# Amendments to the Drawings:

# REMARKS

Application No. 10/609,161 Response to Office Action

F | G. 7

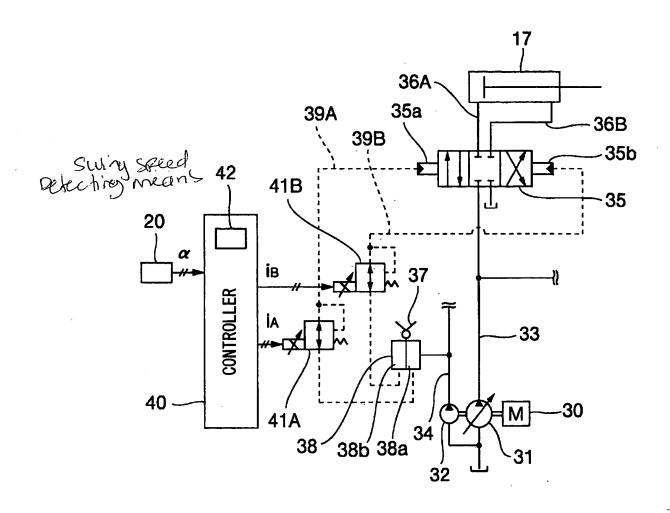
Figs. 7 and 11 have been amended to label element 42 as "Swing Speed Detecting Means," as required by the Examiner.

Figs. 7 and 11 have been amended as described hereinabove to label element 42 as the "Swing Speed Detecting Means," as required by the Examiner.
